INDEPENDENT HEARING AND ASSESSMENT PANEL
CONCEPT PLAN FOR CATHERINE HILL BAY & GWANDALAN

FINAL REPORT

CATHERINE HILL BAY CLIFF LINE ANALYSIS

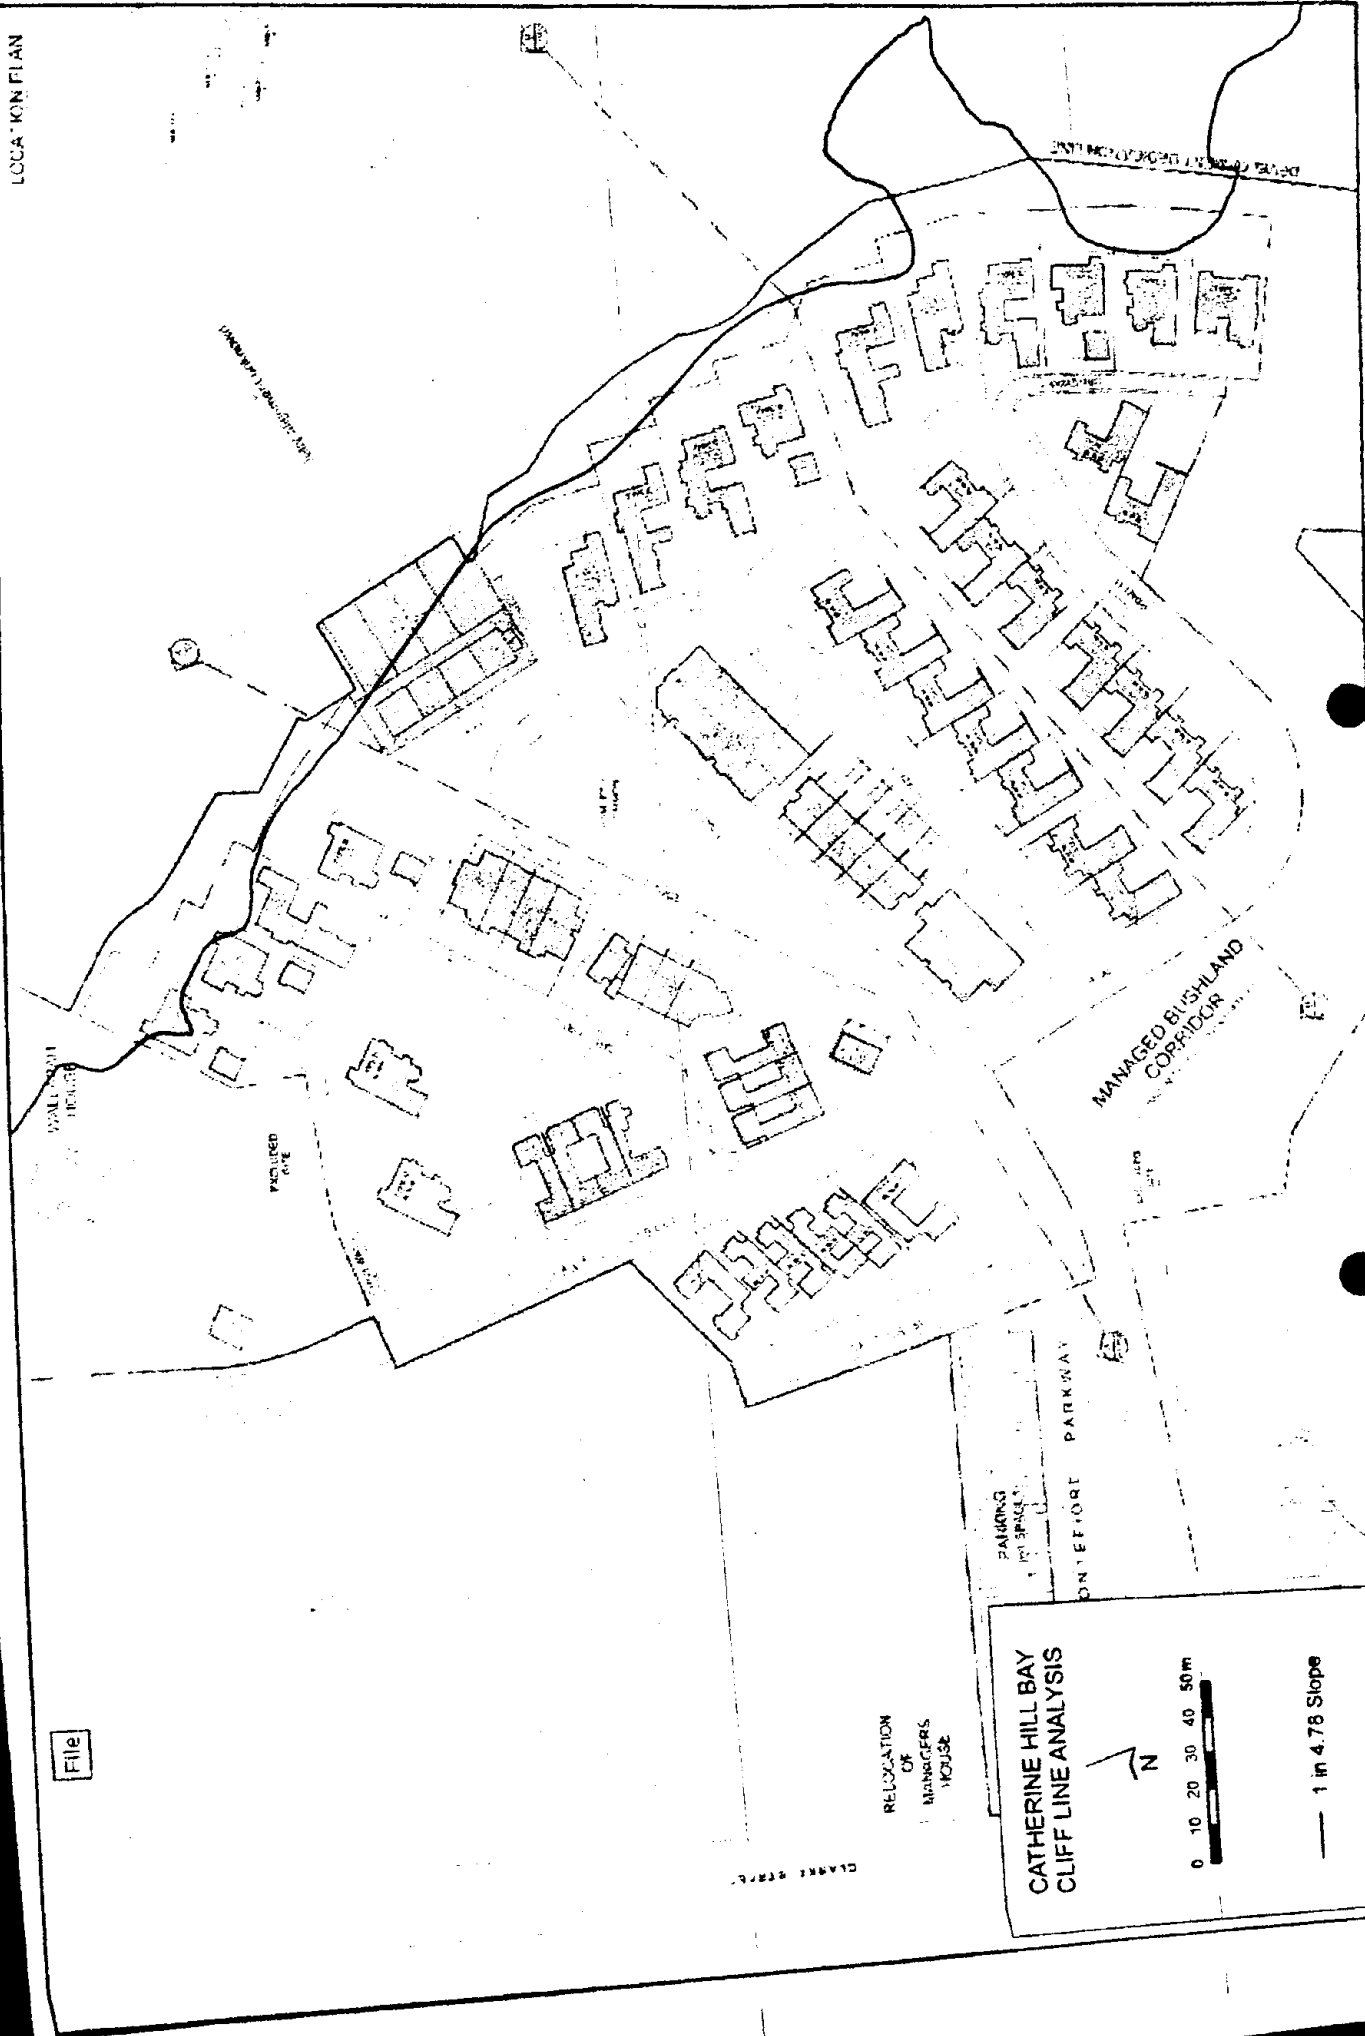
For the purpose of identifying the 25m setback requirement the Panel recommends that the "cliff edge" is defined as the line that represents the point where the land at the cliff edge has a slope of 1 in 4.78 or 20.9% (refer Figure 1 in main body of report).

The Panel is of the view that the proposed coastal walk should be a minimum width of 25m to ensure adequate width for the walk itself and an appropriate setback from the cliff edge to mitigate against cliff retreat, ensure cliff stability etc.

It is also considered that dwellings on adjacent allotments should be setback a minimum of 15m from the allotment boundary to ensure visual separation between the coastal walk and private dwellings.

- All development (including proposed allotments) shall be setback a minimum distance of 25m from the cliff edge (with the exception of development associated with the provision of a public lookout and associated small scale café / kiosk on top of the existing Bin Building). If a greater setback is required for cliff stability reasons then this shall be accommodated in the revised design.
